ADDENDUM NO. 2

DPW Project #2023256

April 30, 2024

**DPW/UI – Ag Science Building HVAC Phase Two
University of Idaho
Moscow, Idaho**

A1 ROOF - OVERALL PLAN

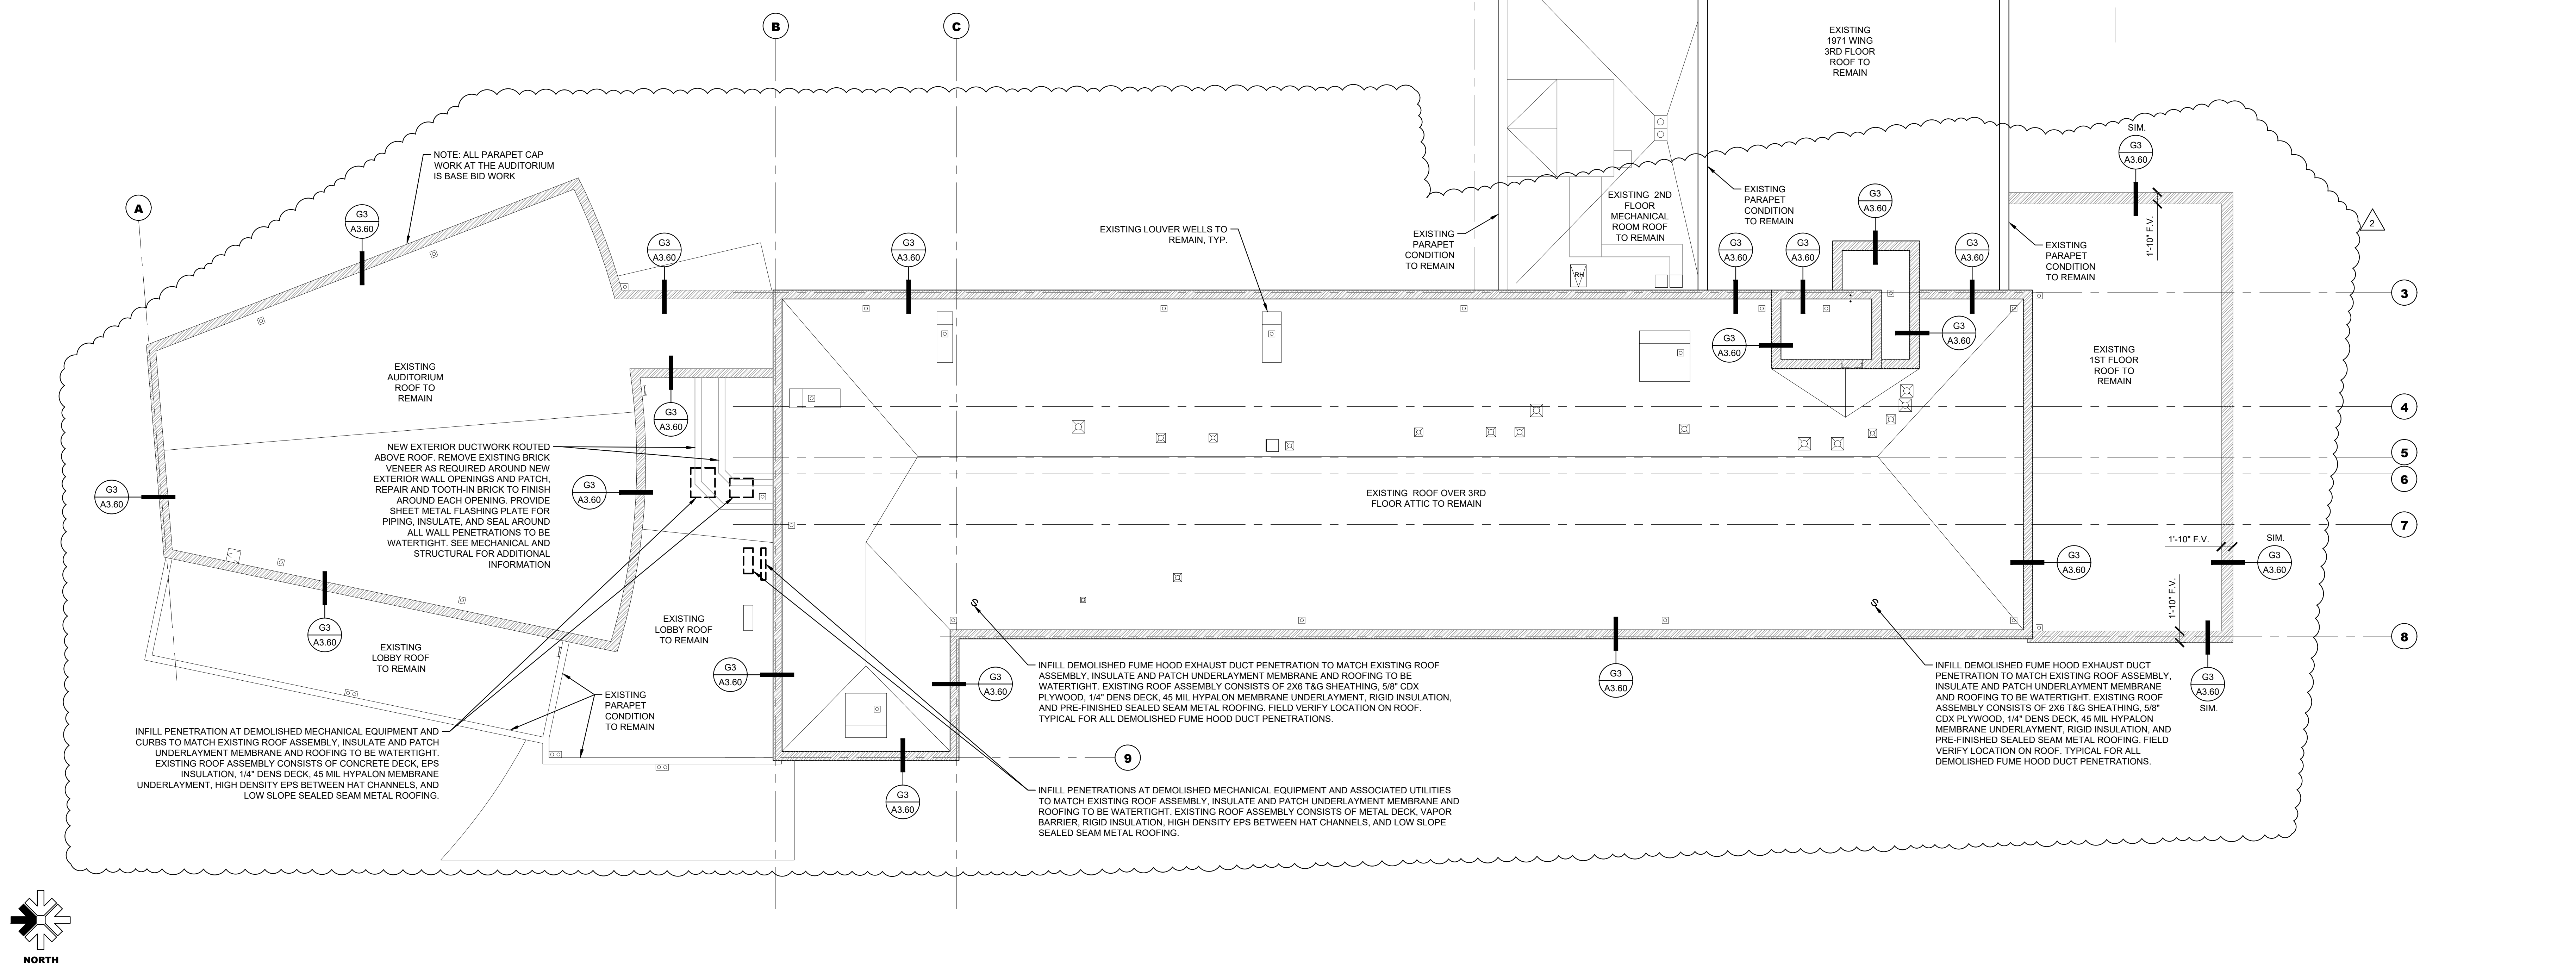
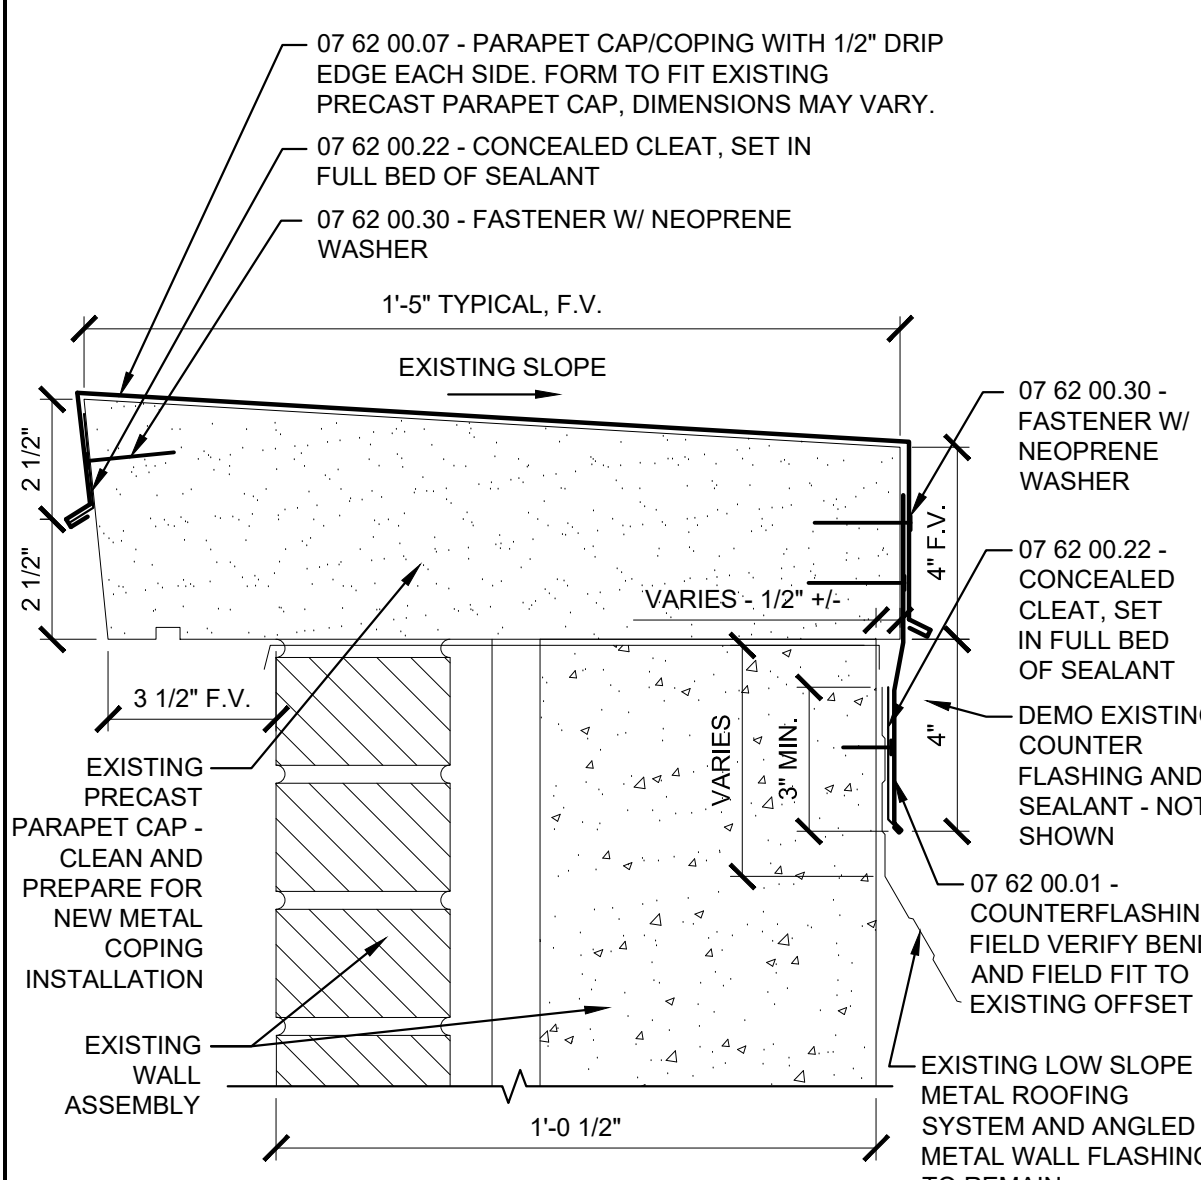
ADDITION: Revise the roof plan as shown on the attached drawing to add new metal coping over the existing building's pre-cast parapet caps. The new metal coping will interface with the building's existing low slope metal roof system, and the coping installation shall maintain the Owner's existing 30 year roofing warranty which began in May of 2014. The new coping metal shall be added to the coverage of the Owner's existing roofing warranty to provide an edge-to-edge warranty. The coping metal and any related accessories shall be supplied by the existing roof system manufacturer, and installed by a manufacturer certified installer. The existing roof system is R-Mer Lite as manufactured by The Garland Company. No substitutions will be allowed due to the requirement to maintain the Owner's existing warranty.

SHEET
S3.32

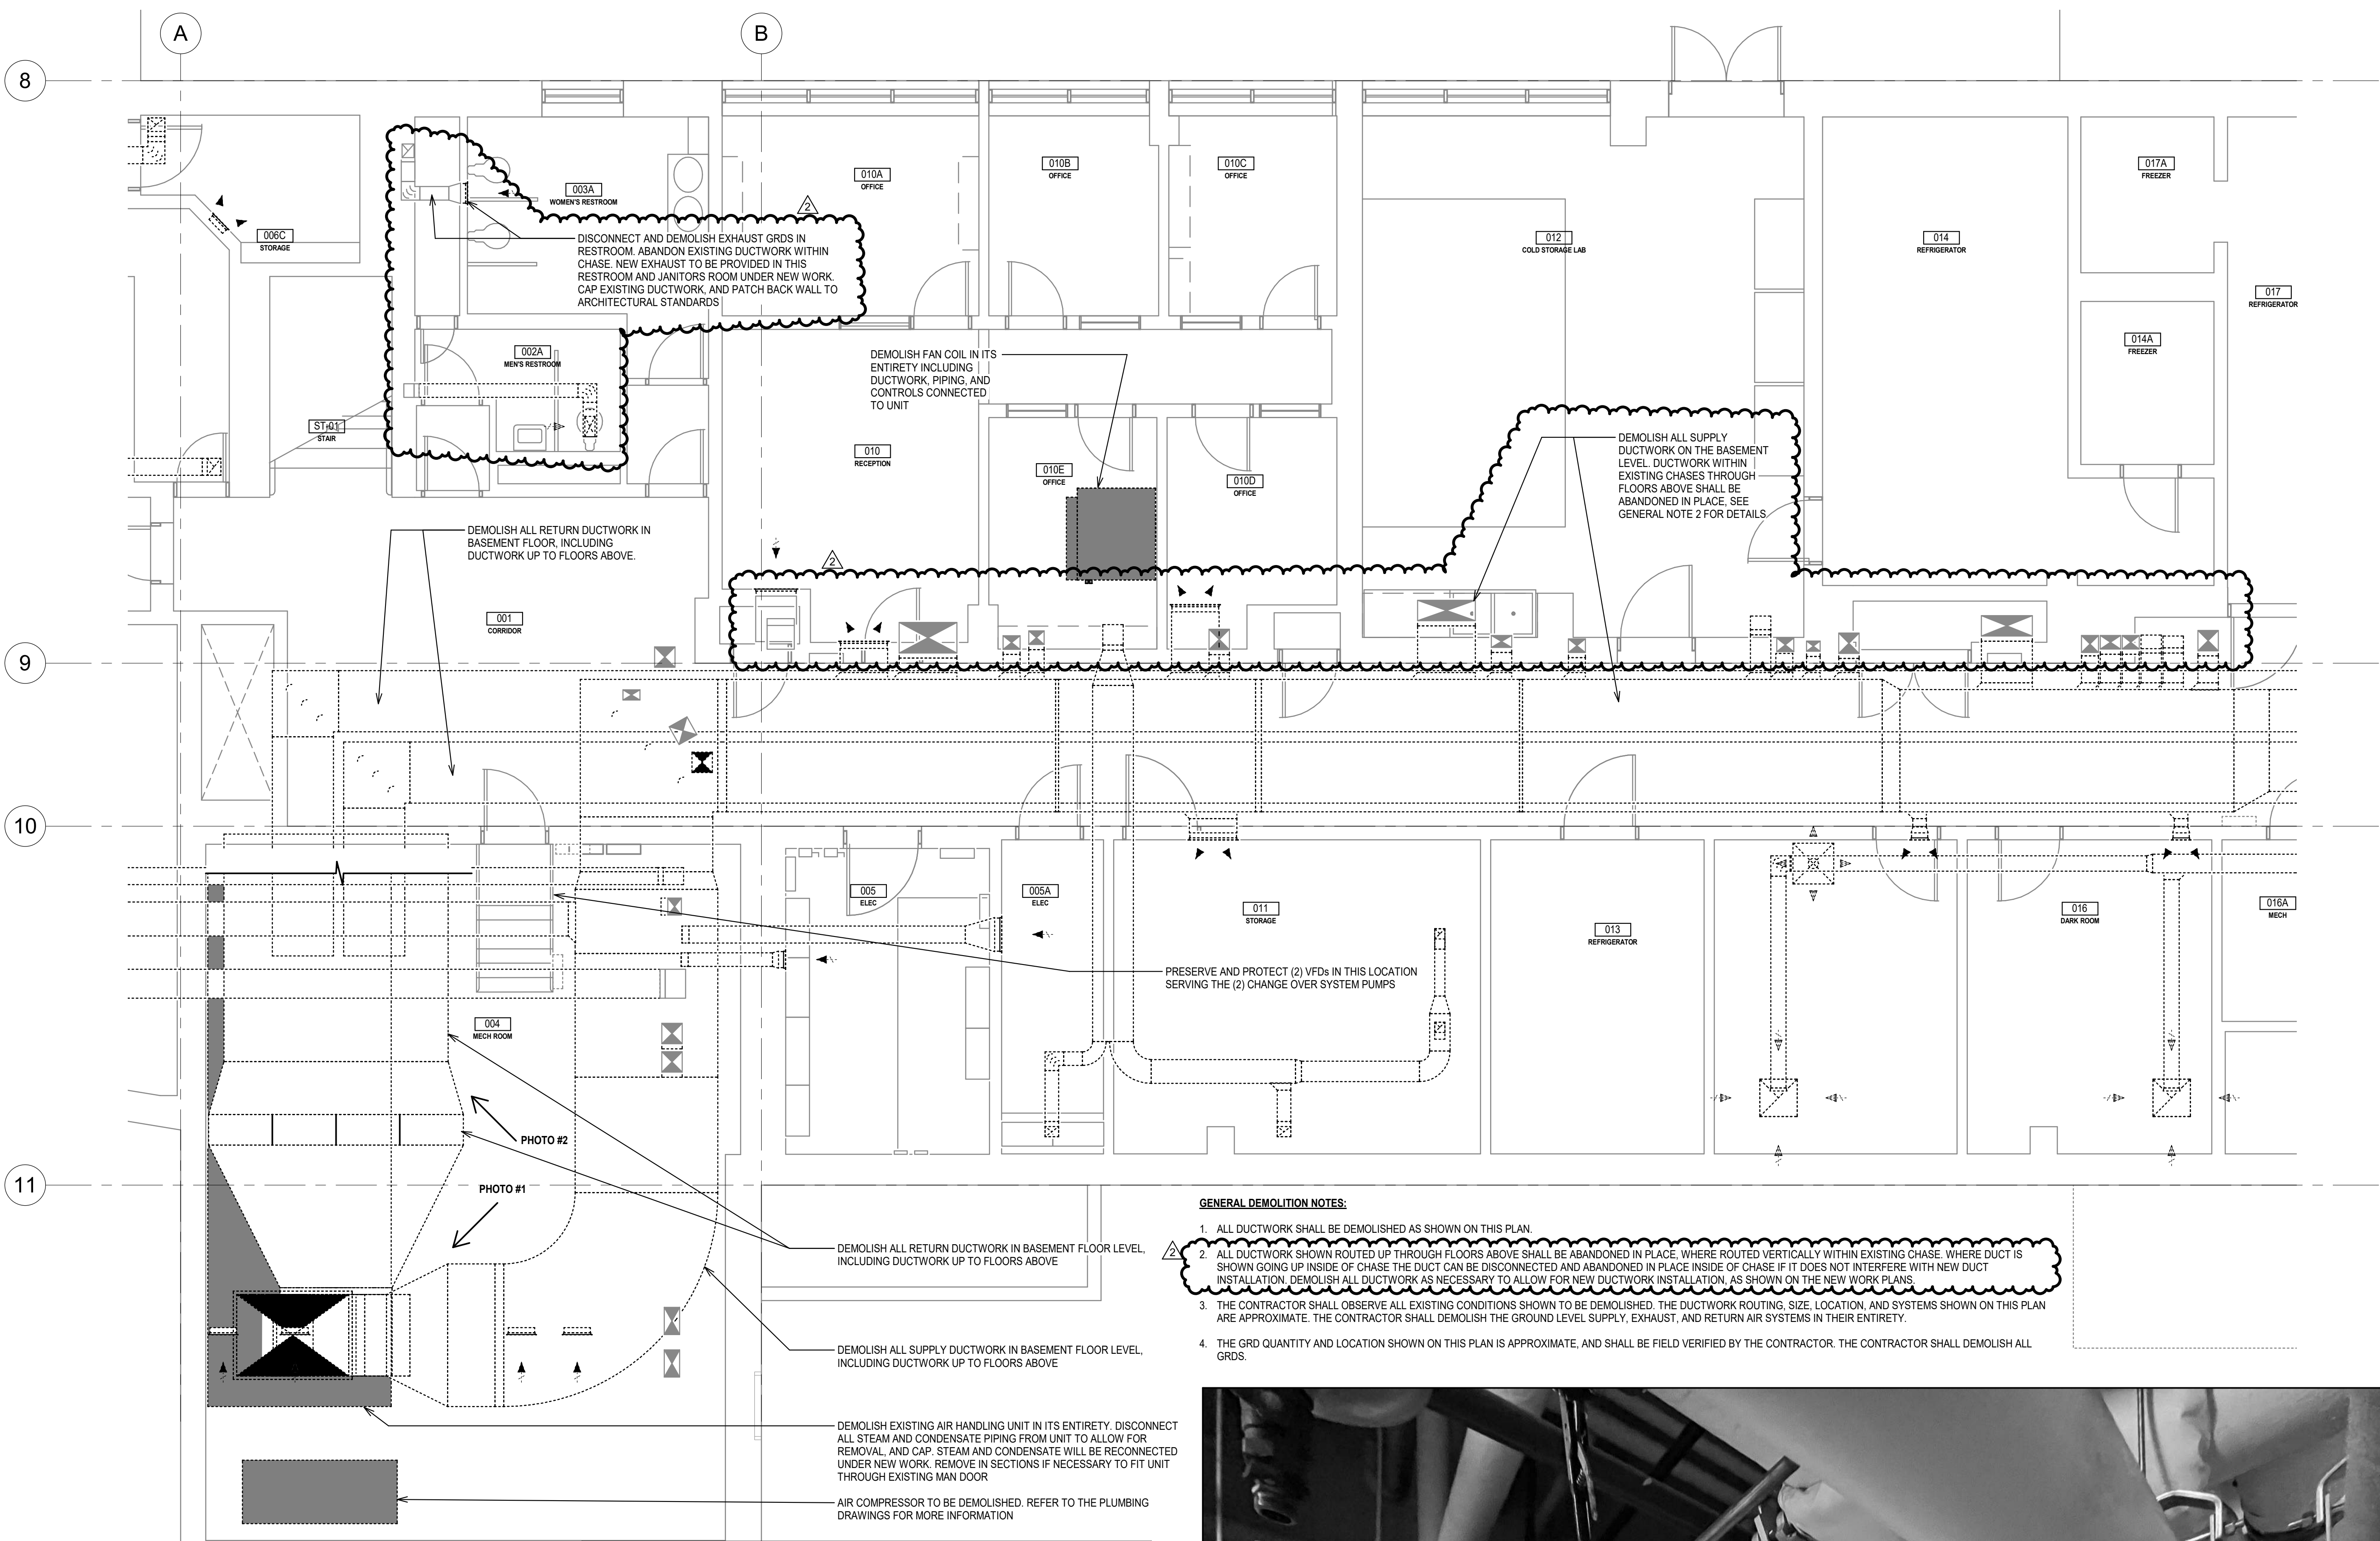
ADDITION: Wall penetrations added at roof to rooms 204 and 205 for routing of mechanical system. Reference attached updated sheet S3.32.
